1963 Corvette: Service Bulletin: Interim Production Changes

Subject: Interim Production Changes
Model and Year: 1963 Corvette
Source: Chevrolet Technical Service Bulletin
Bulletin No: DR #569
Section: XV
Date: December 31, 1962

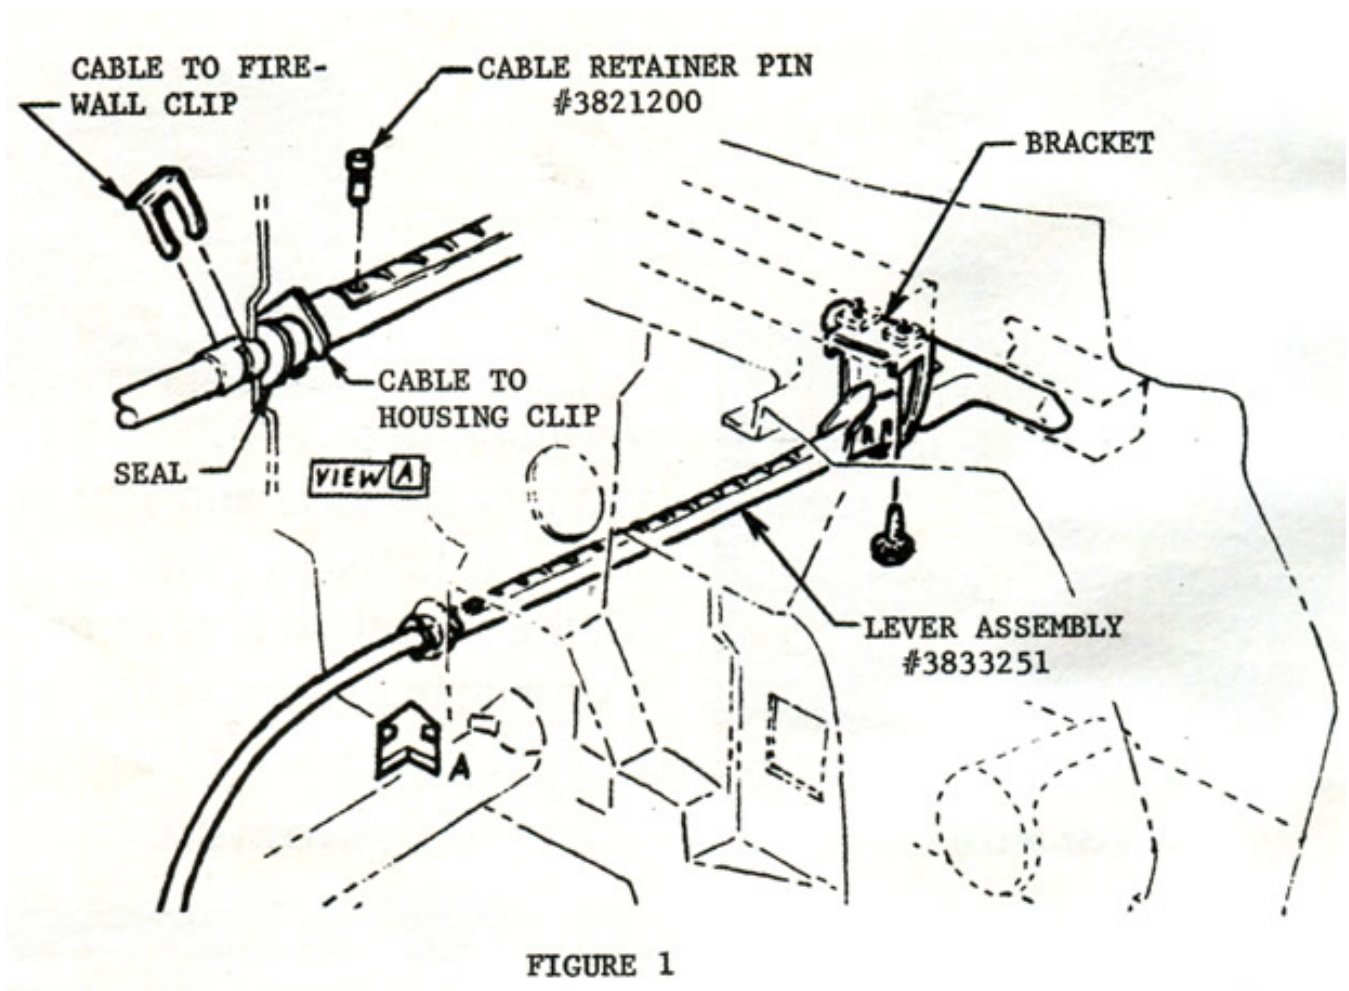
1. Effective with Serial No. S101893, a redesigned parking brake lever assembly entered Production. Early vehicles incorporate a lever assembly which may be difficult to release and in extreme cases, may actually jam making release impossible.
2. Vehicles with Serial No. S101847 through S102667, were built with a second design rear axle driveshaft flange that may not seat properly in the rear wheel drive spindle flange. An interference condition at this location could possibly lead to early failure of the rear wheel spindle flange attaching bolt bosses.

Lever Assembly should be replaced on all vehicles built prior to Serial No. S101893. Referring to Figure

1, proceed as follows:

1. Scrape sealer away from cable to firewall clip and remove clip.
2. Disconnect parking brake cable clip from steering gear retainer bolt.
3. Disconnect oil pressure line at gauge and pull line out of parking brake lever assembly bracket.

4. Remove two (2) bolts holding bracket to dash brace.
5. Pull complete lever and cable assembly to the rear, far enough to remove parking brake signal switch.

6. With handle all the way in, cable retainer pin will line up with hole in bottom of housing allowing pin to be driven out from bottom with a punch.
7. Remove cable to housing clip and separate cable from housing.

8. Install original seal on new lever assembly No. 3833251.
9. Reassemble by reversing the above steps using new cable retainer pin No. 3821200. NOTE:
Chamfered side of pin must face forward to actuate the parking brake signal switch properly.

FIGURE 2

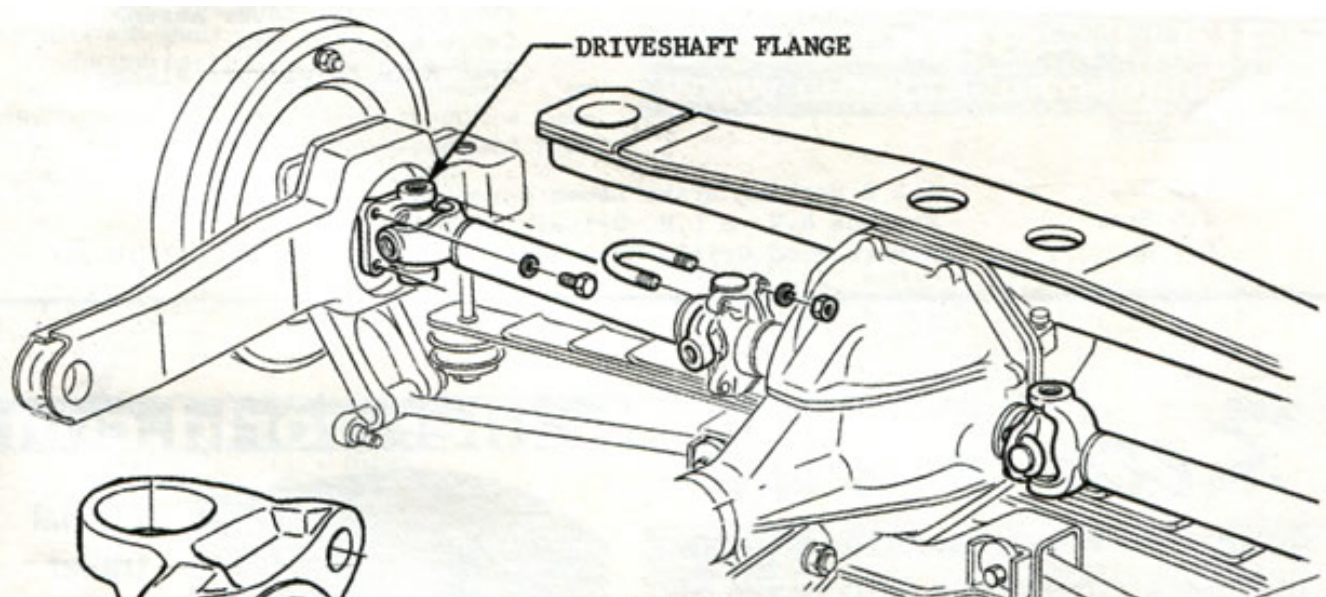
REAR AXLE DRIVESHAFT FLANGE REPLACEMENT

New machined Driveshaft Flanges No. 3832048, should be installed on all vehicles with Serial No.

S101847 through S102667 (Ref. Figs. 2 and 3).

Vehicles built after S102667 incorporate selective fit pieces or additional machining to insure adequate clearance.

FIGURE 3 - DRIVESHAFT FLANGE

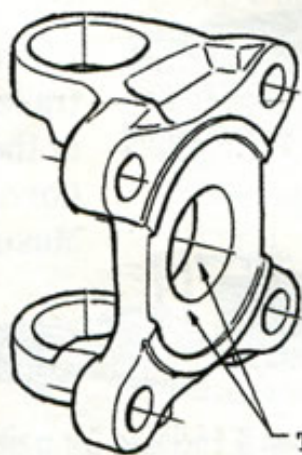
THESE SURFACES
MACHINED FOR
CLEARANCE

FIGURE 4 - SPINDLE FLANGE

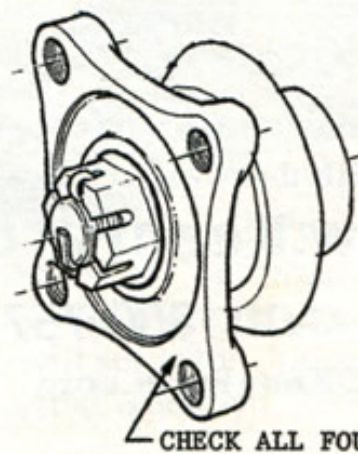
Replacement of the driveshaft flange is covered in the 1963 Corvette Shop Manual, Page 4-16. The rear wheel spindle flange attaching bolt bosses should be visually inspected while the axle driveshafts are out of the vehicle. Replace with new Spindle Flange Assembly No. 3830253 if any cracks are evident in the area indicated in Figure 4.

CHECK ALL FOUR
BOSSES FOR CRACKS
IN THIS AREA
